ECE/TRANS/WP.29/GRE/2008/16
18 January 2008

Regulations Nos. 6, 7 and 48

Proposal for Supplement 18 to the 01 series of amendments Regulation No. 6
(Direction indicators)

Submitted by the expert from France */

Minimum horizontal visibility angles

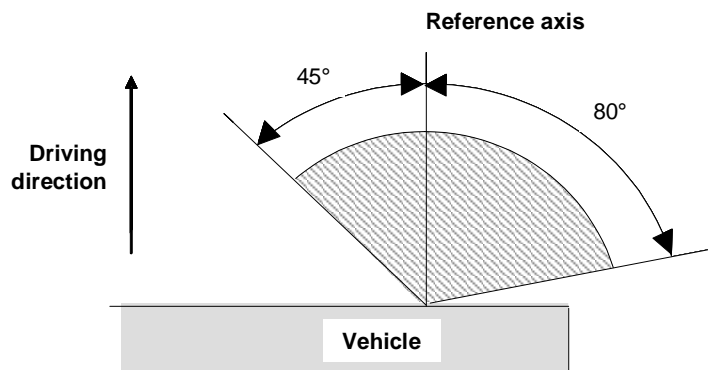
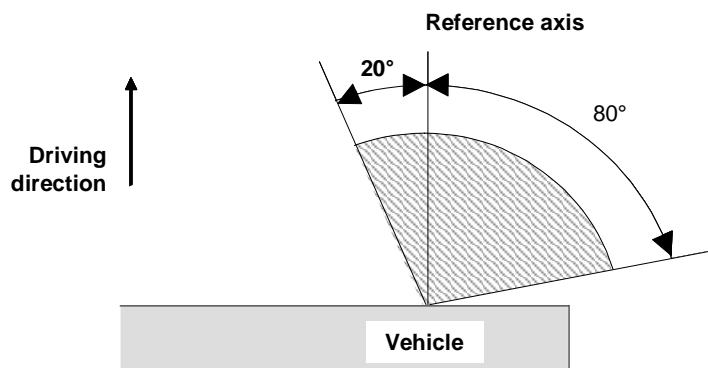
The text reproduced below was prepared by the expert from France proposing to align with the state-of-the art realizations for the visibility angles requirements of the direction indicators. It supersedes ECE/TRANS/WP.29/GRE/2007/65, distributed during the fifty-eighth session of the Working Party on Lighting and Light-Signalling (GRE) (see report ECE/TRANS/WP.29/GRE/58, para. 32). The modifications to the current text of the Regulation are marked in **bold** characters.

The current visibility requirements of the front and rear direction indicators and position lamps were written in the early 1970s. They were easily fulfilled in those times because the shapes of the vehicles were simple and rather boxy. Recent styling trends based on better aerodynamics and pedestrian protection lead to contoured shapes making the fulfilment of the 15° down and 45° inboard (15D-45inboard) visibility requirement impossible to achieve.

The interior visibility angle reduction of the front direction indicator from 45° to 20° has a minimum impact on the distance of visibility of the vehicle when observed along its longitudinal median plan. In the case of a vehicle with 1,400 mm between the reference axis of the direction indicator lamps, this angular reduction, as seen by an observer squatting on the median longitudinal plan of the vehicle, leads to a minimal change of just 1.22 m:

With the current visibility angle, the lamp is visible at $D_1 = 1,400 \times 0.5 \cotg 45^\circ = 700$
 With the proposed visibility angle, the lamp is visible at $D_2 = 1,400 \times 0.5 \cotg 20^\circ = 1,923$
 The "danger" distance is increased by a modest

$$D_2 - D_1 = 1,400 \times 0.5 (\cotg 20^\circ - \cotg 45^\circ) = 1,223 \text{ mm.}$$

On and above the H plane

Under the H plane

H plane : "horizontal plane going through the reference centre of the lamp"
